**STAFF REPORT**  
**KETCHUM PLANNING AND ZONING COMMISSION**  
**REGULAR MEETING OF AUGUST 13, 2019**

**PROJECT:** Mountain Land Design Showroom

**FILE NUMBER:** P19-075

**APPLICATION TYPE:** Design Review

# BASEMENT FLOOR PROPOSED FLOOR PLAN

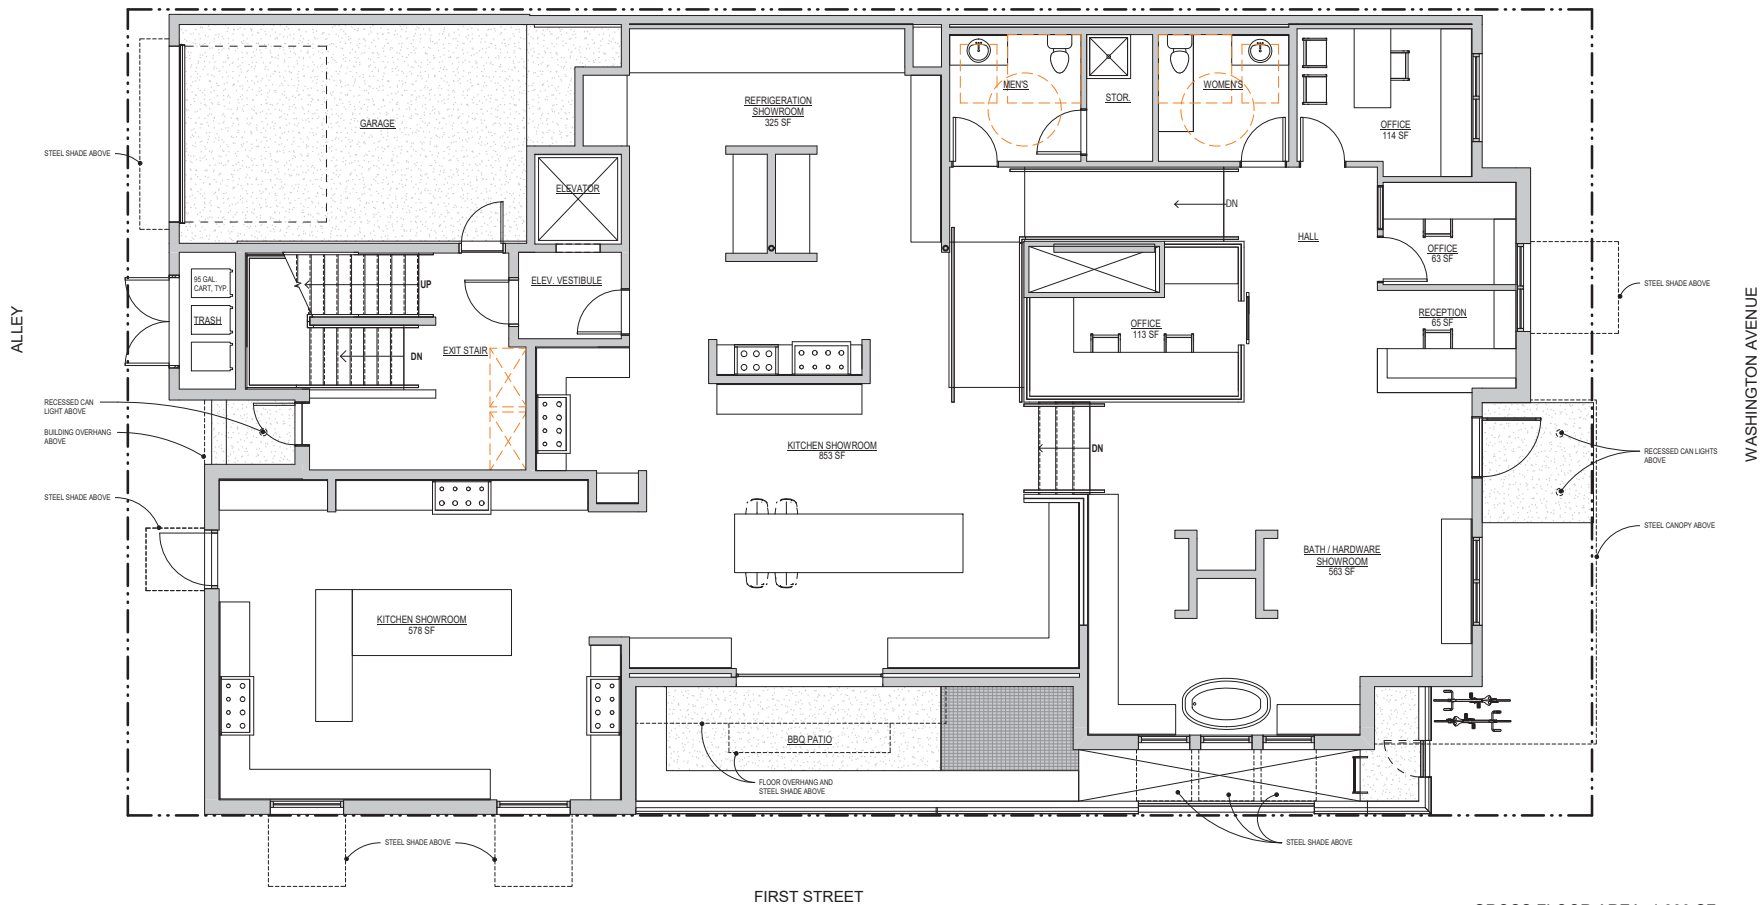
Compliance with Zoning Standards				
Compliant			Standards and Staff Comments	
Yes	No	N/A	Ketchum Municipal Code §	City Standards and Staff Comments
<input type="checkbox"/>	<input checked="" type="checkbox"/>	<input type="checkbox"/>	<b>17.12.040</b>	<b>Minimum Lot Area</b>
			<b>Staff Comments</b>	<b>Required:</b> 5,500 square feet minimum <b>Existing:</b> No change; lot is 5,500 square feet.
<input checked="" type="checkbox"/>	<input type="checkbox"/>	<input type="checkbox"/>	<b>17.124.040</b>	<b>Floor Area Ratios and Community Housing</b>
			<b>Staff Comments</b>	<p><b>Permitted in Community Core Subdistrict 2(CC-2)</b>  <b>Permitted Gross FAR: 1.0</b>  <b>Permitted Gross FAR with Inclusionary Housing Incentive: 2.25</b>  <b>Proposed Gross FAR:</b>  Proposed Gross Floor Area: 6,799 gross square feet</p> <p>Pursuant to the definition of gross floor area (KMC §17.08.020), four parking stalls for developments on single Ketchum Townsite lots of 5,600 sq ft or less are not included in the gross floor area calculation. Two parking stalls 9' x 18' in size have been deducted from the Gross Floor Area total square footage.</p> <p>Gross Floor Area with Parking Discount: 6,799 sq ft  Lot area: 5,500 sq ft  FAR Proposed: 1.24 (6,799 sq ft/5,500 sq ft lot area)  Increase Above Permitted FAR: 1,299 sq ft  20% of Increase: 259 sq ft  Net Livable (15% Reduction): 221 sq ft  Community Housing In-Lieu Fee: \$52,598 (221 * \$238)</p> <p>The applicant has indicated that the 749 square foot residential unit located in the basement is to be a community housing unit. (Refer to Basement Floor Proposed Floor Plan, comment: workforce housing unit 749 sf)</p>
